September 23, 2015  
Amended October 13, 2015

**RE: 732 Poorhouse Lane – Compliance Issues**

619 ELIZABETH ST, KEY WEST, FL.

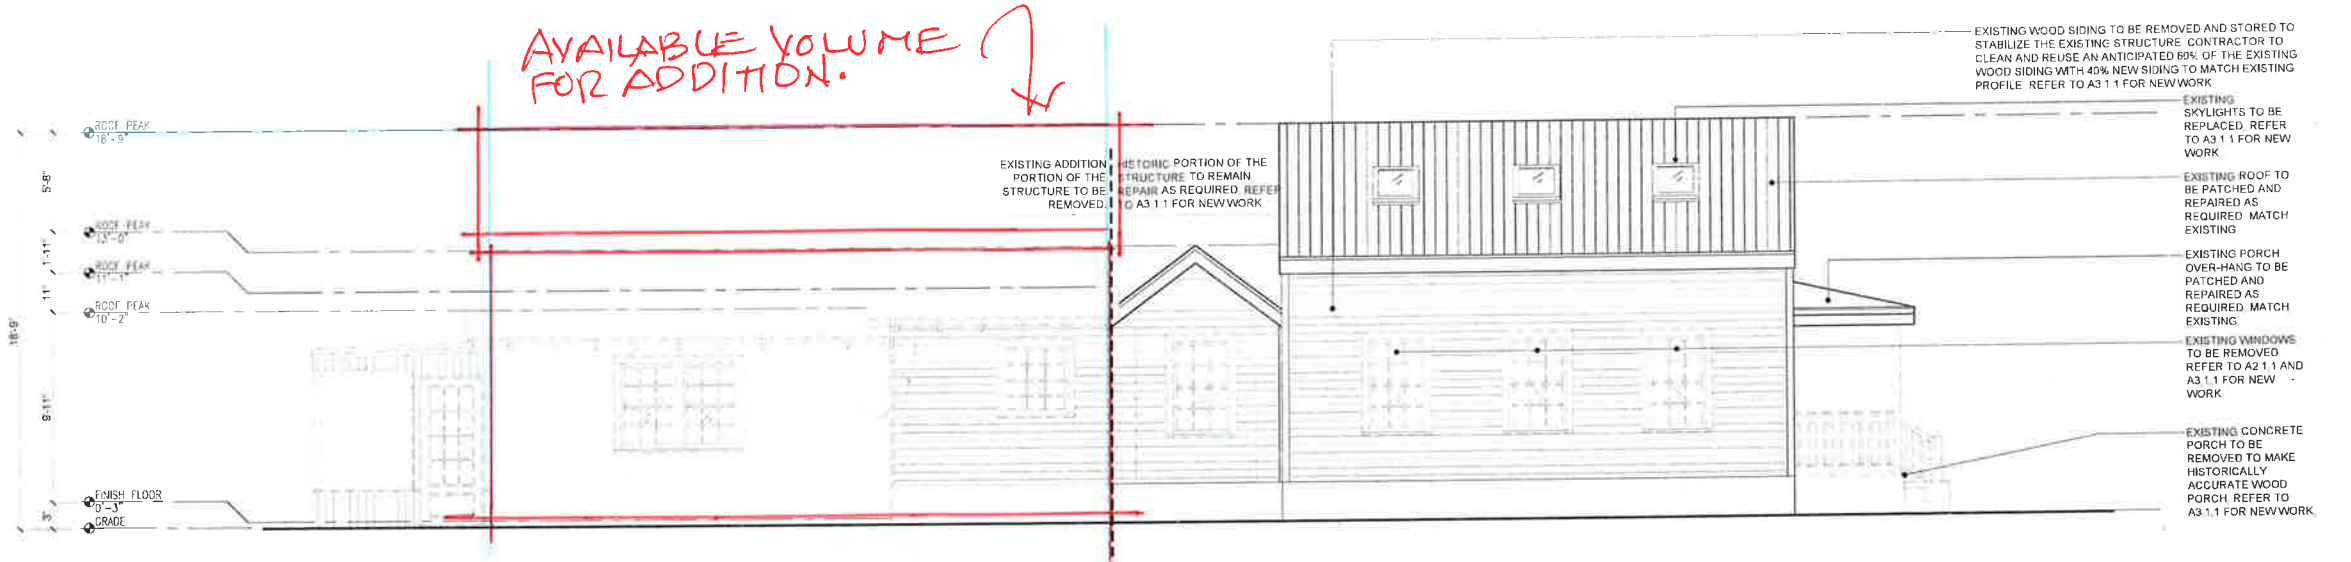
THE CENTRAL FIRST FLOOR ELEMENT IS THE 14 FOOT WIDE LIVING ROOM. THE BUILDING TO THE RIGHT IS A 12'x10' MOTHER-IN-LAW GUEST COTTAGE.

619 ELIZABETH ST., KEY WEST, FL.

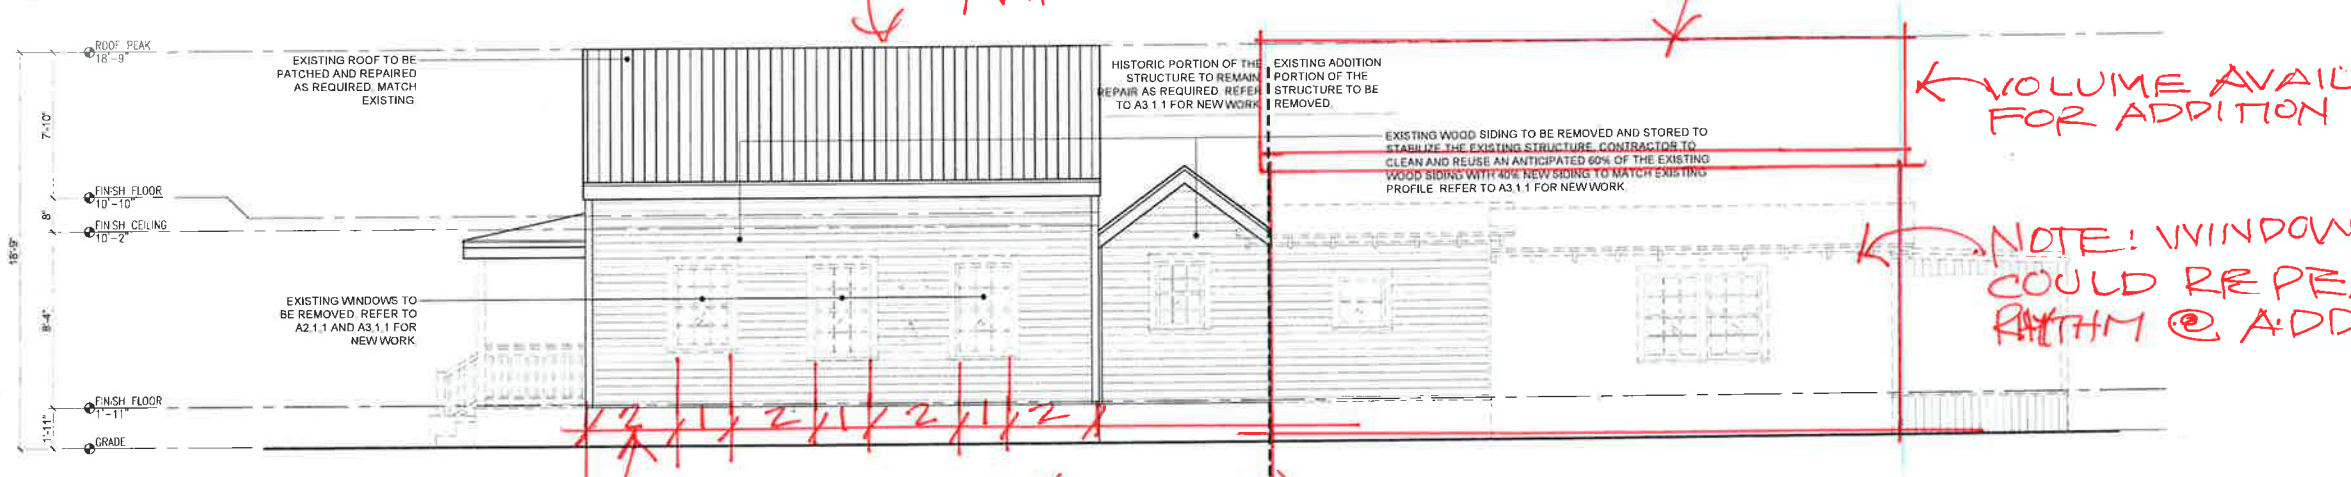
THE LIVING ROOM IS 14' WIDE OVERALL WITH AN INTERIOR WIDTH OF JUST OVER 13 FEET

THE KITCHEN IS 12 FEET SQUARE INCLUDING EXTERIOR WALLS.

2 DEMOLITION NORTH ELEVATION  
SCALE: 1/4"=1'-0"

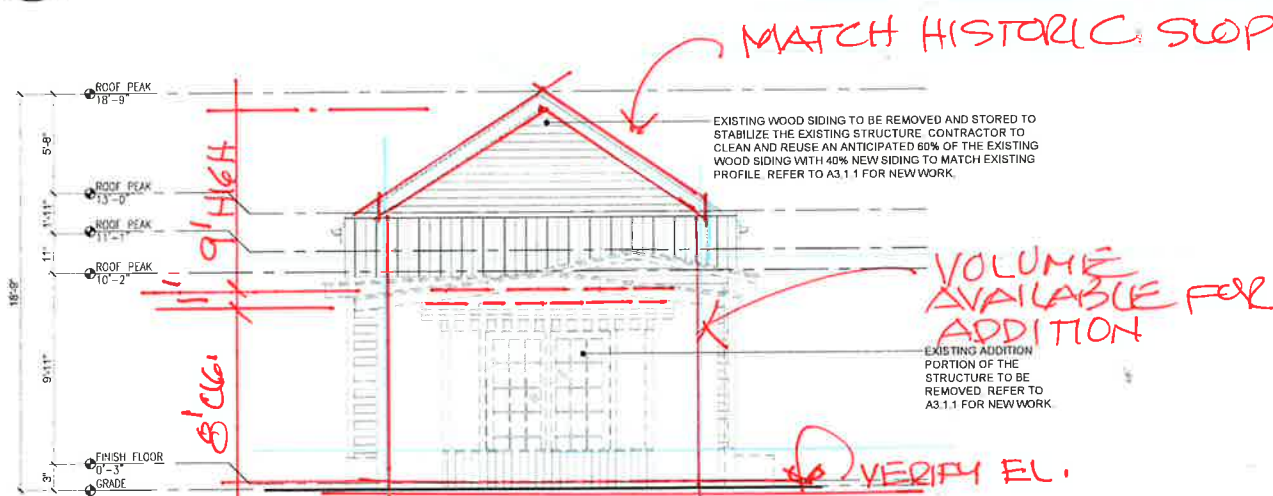
1. The project proposes to demolish non-historic rear additions. Once this is done, the existing zoning violations must be brought into compliance. The lot is 24 feet wide with required side yard setbacks of 5 feet. This reduces the allowable width of the rear addition to 14 feet, but the submittal shows a larger structure. A 14 foot wide building is more than adequate, as the attached photos show.

- a) Height: (Pg. 38a) “The height of all new construction must be based upon the height of existing structures...” Under this guideline, the height of the new addition should not exceed the height of the existing building. The shed roof dormer in its current configuration, creates an out of scale mass.

14' IF SETBACKS ARE HONORED  
16' W/ VARIANCE

NOTE: THE LIVING ROOM/DINING ROOM/STUDIO/DEN SPACE @ 619 ELIZABETH (BENDER RESIDENCE) IS 14 FEET WIDE.
